Project	<b>IEEE 802.16 Broadband Wireless Access Working Group</b> < <a href="http://ieee802.org/16">http://ieee802.org/16</a> >	
Title	<b>Comments on Zone Switch based Handover Procedure for IEEE P802.16m/D1 (15.2.5.11.1.2.1)</b>	
Date Submitted	<b>2009-08-28</b>	
Source(s)	Yih-Guang Jan, Yang-Han Lee, Hsien-Wei Tseng, Ming-Hsueh Chuang, Jheng-Yao Lin <b>Tamkang University (TKU)</b>	yihjan@yahoo.com
	Youn-Tai Lee, Chun-Yen Hsu <b>Institute for Information Industry (III)</b>	lyt@nmi.iii.org.tw
	Shiann-Tsong Sheu <b>National Central University (NCU)</b>	stsheu@ce.ncu.edu.tw
	Whai-En Chen <b>National Ilan University (NIU)</b>	wechen@niu.edu.tw
	Shiunn-Jang Chern <b>National Sun Yat-sen University(NSYSU)</b>	chern@mail.ee.nsysu.edu.tw
Re:	IEEE 802.16 Working Group Letter Ballot #30: P802.16m/D1	
Abstract	Comments on Zone Switch based Handover Procedure for IEEE P802.16m/D1 (15.2.5.11.1.2.1)	
Purpose	To be discussed and adopted by TGM for IEEE P802.16m/D1.

## **Comments on Zone Switch based Handover Procedure for IEEE 802.16m/D1 (15.2.5.11.1.2.1)**

Figure 409-Handover procedure from YBS to ABS: the T-ABS instructs AMS to switch zone after completion of network reentry at LZone

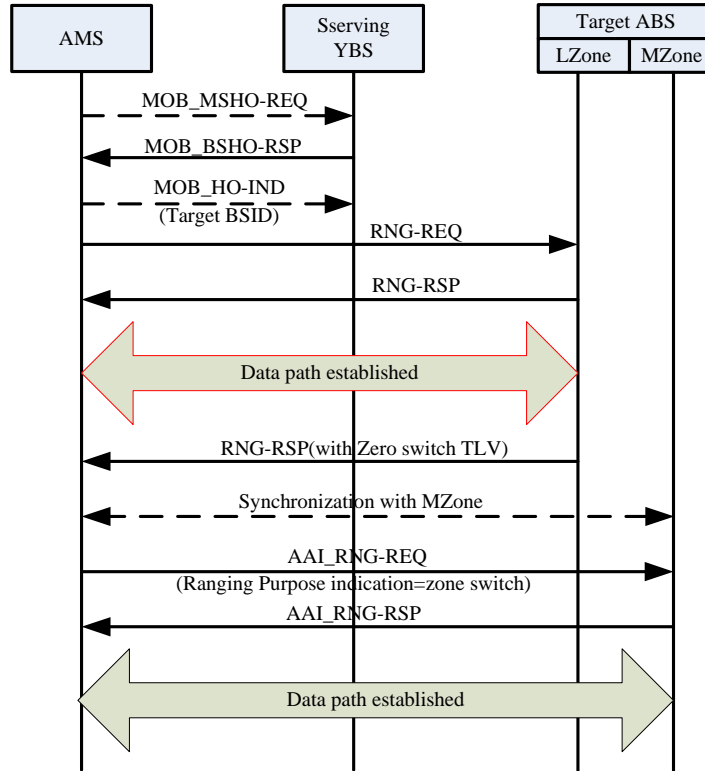
This contribution provides the corrected figure in the description of Zone Switched based Handover Procedure. It has an error in the description of 'Data Path Established' in Figure 409.

*[In IEEE P80216m/D1, Section 15.2.5.11.1.2.1, replace Figure 409 by the following corrected figure]*
